UNITED STATES PATENT AND TRADEMARK OFFICE

APPLICATION NO.	FILING DATE	FIRST NAMED INVENTOR	ATTORNEY DOCKET NO.	CONFIRMATION NO.
10/633,296	07/31/2003	Michael Czynsz	MCZ005	3325

Office Action Summary	Application No. 10/633,296	Applicant(s) CZYSZ, MICHAEL	
	Examiner Saúl J. Rodríguez	Art Unit 3681

DETAILED ACTION

Fig. 2

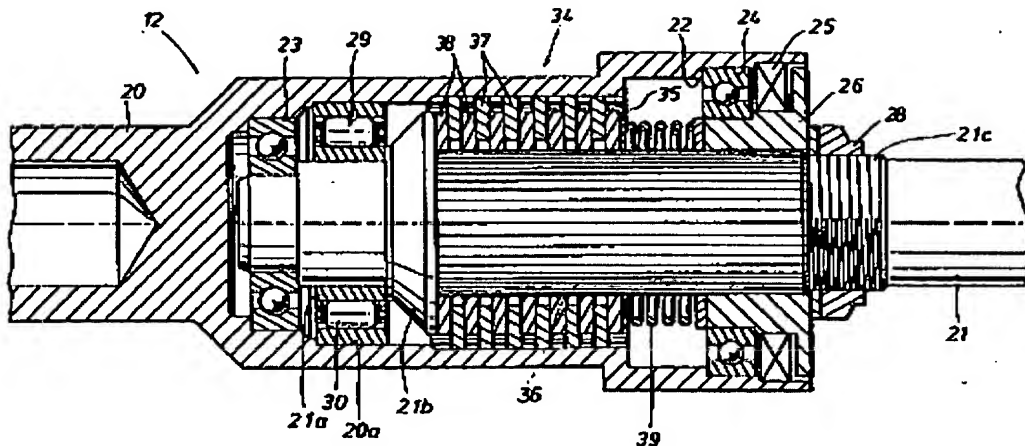
Masuda et al. ('507) discloses a motor vehicle (Fig. 1), comprising a chassis, an internal combustion engine (E), a gearbox at a first end of the vehicle, a gearbox output shaft (10) wheels (18, 19), a slipper clutch providing positive sprag engagement and slip, sprags (30) at a second end of the vehicle, a clutch basket (20), a stack of drive plates (37, 38), and a spring (39).

FIG.1

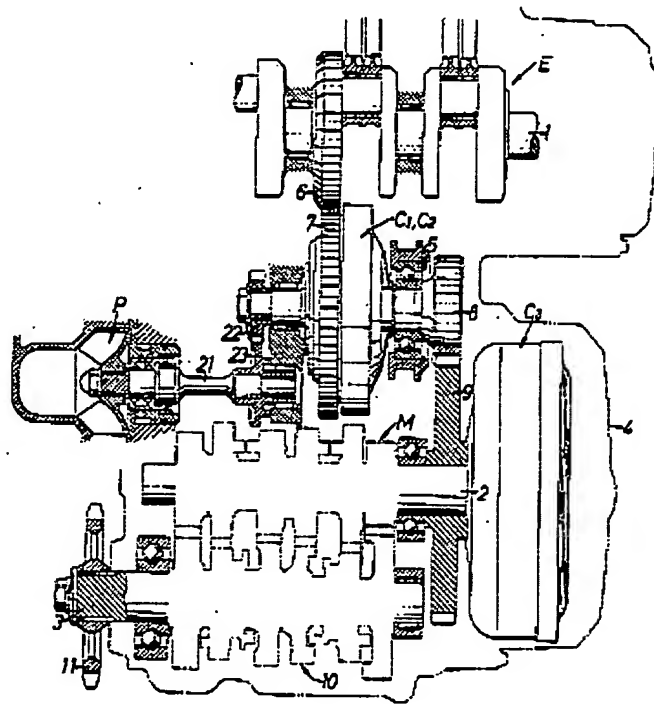
Gotoda ('989) discloses a motorcycle (Col. 1, lines 8-9) drivetrain (Fig. 1), an internal combustion engine (1) at a first end of the vehicle, a gearbox output shaft (3) at a second end of the vehicle, a conventional gearbox clutch (C3), a slipper clutch (C1, C2), a gear (9), a sprag coupling (14), a basket (17), drive plates (18, 19), and a spring (20).

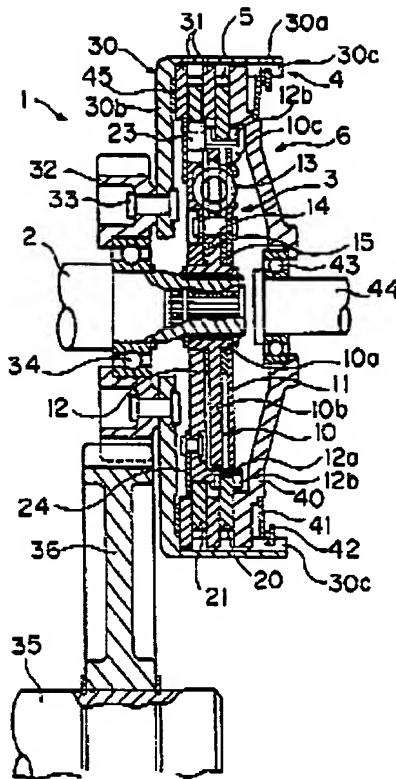
Kajitani et al. discloses a motorcycle comprising a chassis (Col. 1, line 17), an internal combustion engine (Col. 8, line 41), a primary clutch (60), a positive engagement one-way clutch (68, Fig. 2), a crankshaft (51), a gearbox output shaft (49), a slipper clutch (Fig. 2), a clutch basket (60a), a stack of drive plates (67), a spring (71), an adjustable (Col. 7, 62-65) tensioner (75).
